**CITY OF TEMPE
DEVELOPMENT REVIEW COMMISSION**

Meeting Date: 08/08/2017
Agenda Item: 5

ACTION: Request approval for a Use Permit to allow tandem parking; a Use Permit Standard to increase the maximum allowed building height from 30 to 32 feet; and a Development Plan Review for a new 20-unit, attached single-family development for 2nd & HARDY TOWNHOMES, located at 225 South Hardy Drive. The applicant is Pacific Rim Property Investments, Ltd.

1 Architectural Site Plan
 ALL MECHANICAL UNITS TO BE ROOF MOUNTED AND SCREENED FROM VIEW
 MAILBOXES SHALL BE LIT BY A MINIMUM 5 FOOT CANDLES OF LIGHT WITHIN A 15 FOOT RADIUS.
 SCALE: 1" = 20'

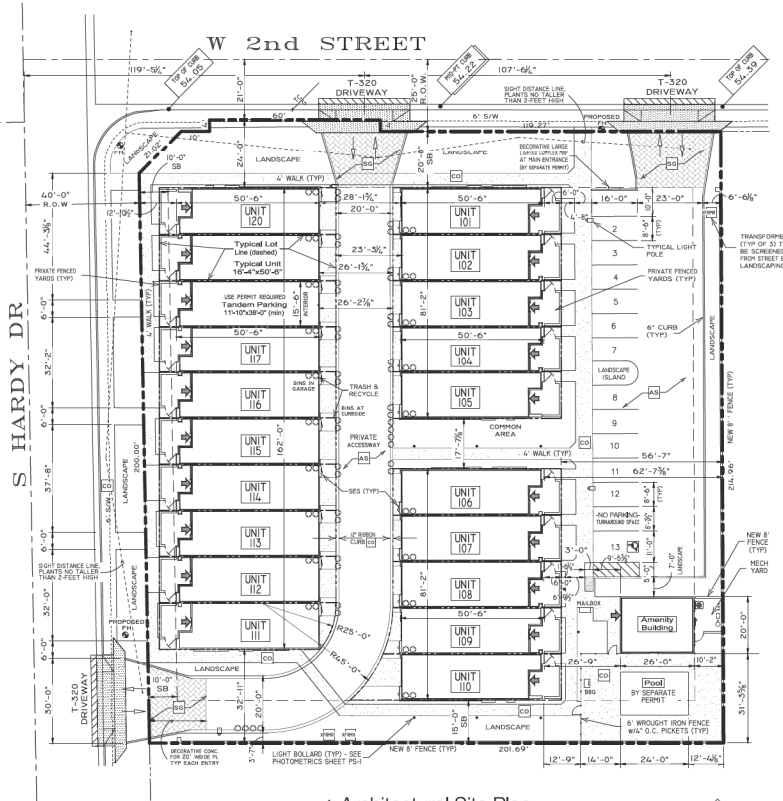
3. Provide a minimum of four (4) bicycle parking spaces for guests.
4. The turnaround space noted on site plan, located in the row of guest parking spaces and accessed from 2nd Street, shall be striped and demarcated for no parking.
5. Provide a parking screen wall on 2nd Street. Wall should have a height that does not exceed four (4) feet and constructed of integral colored CMU to match dwelling patio walls.
6. Provide service yard and mechanical (cooling tower/generator) yard walls that are at least 8'-0" tall as measured from adjacent grade and are at least the height of the equipment being enclosed, whichever is greater. Verify height of equipment and mounting base to ensure that wall height is adequate to fully screen the equipment. Locate electrical service entrance sections inside the service yard.

7. Provide gates of steel vertical picket, steel mesh, steel panel or similar construction. Where a gate has a screen function and is completely opaque, provide vision portals for visual surveillance. Provide gates of height that match that of the adjacent enclosure walls. Review gate hardware with Building Safety and Fire staff and design gate to resolve lock and emergency ingress/egress features that may be required.

8. Provide upgraded paving at each driveway consisting of integral colored unit paving. Extend this paving in the driveway from the right-of-way line to 20'-0" on site and from curb to curb at the drive edges. From sidewalk to right-of-way line, extend concrete paving to match sidewalk.

E Five- or Ten-Plex Right End Elevation

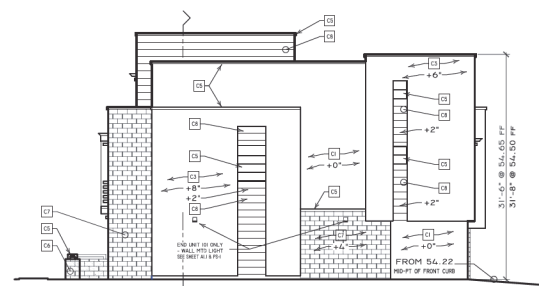
14. The lower pop-out stucco element on Right End Elevations should be raised in height six (6) to twelve (12) inches to provide more visual interest in this elevation by shifting the vertical planes.

LANDSCAPE PLAN

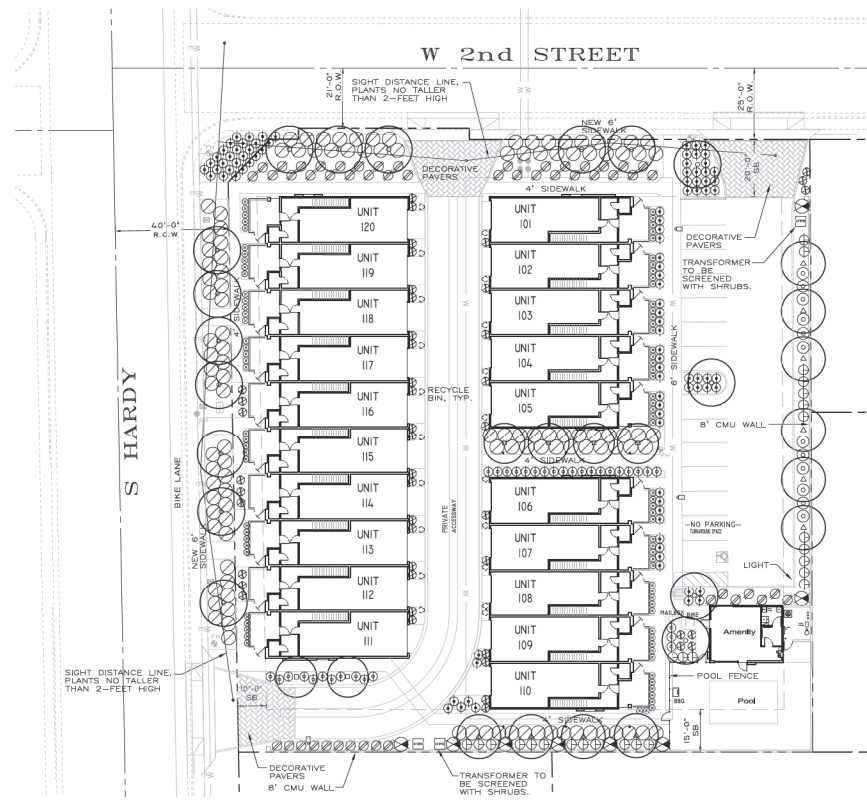
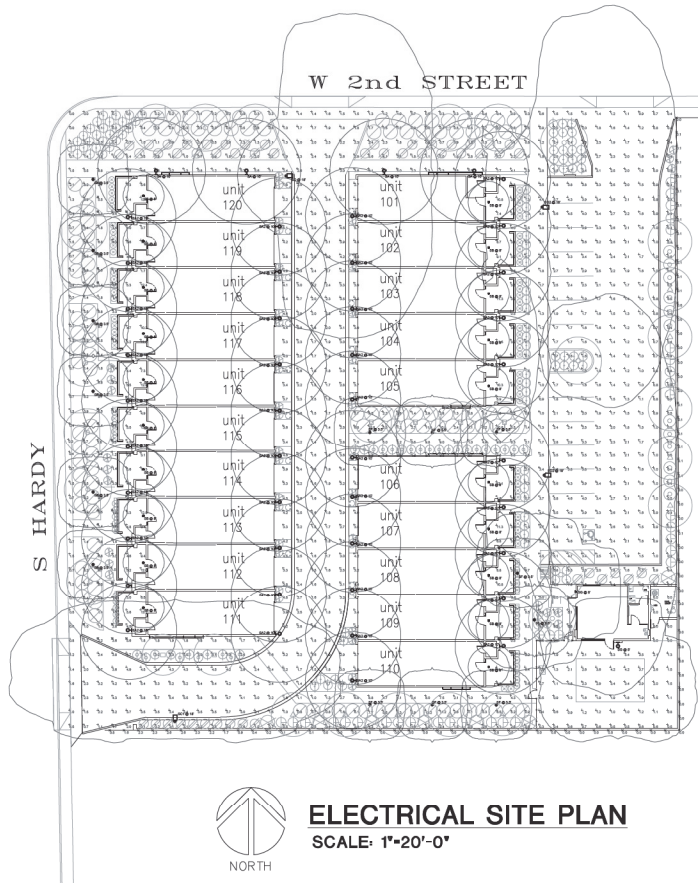
1. Staff not in support of Chitalpa as a street tree.

Project is providing 25.6% of landscape coverage. Staff has conditioned that Chitalpa not be used as a street tree specimen and provide a minimum of 50% ground cover. Applicant is providing trees along east property line which abuts a multi-family residence, these trees should assist in providing privacy for both developments.

22. Project should provide a minimum of six (6) street trees along 2nd Street and seven (7) along Hardy Drive.
23. Chitalpa is not allowed as a street tree. Provide Red Push Pistache, Delbergia Sissoo or Arizona Ash as a street tree. Only use one specimen type for street trees.

24. Provide a minimum of 50% ground cover in landscape areas with shrubs and accents, non-organic materials should not count towards this calculation.
25. Arterial street trees shall be a minimum of 36" box specimens and a minimum of 1 ½" caliper trunk.
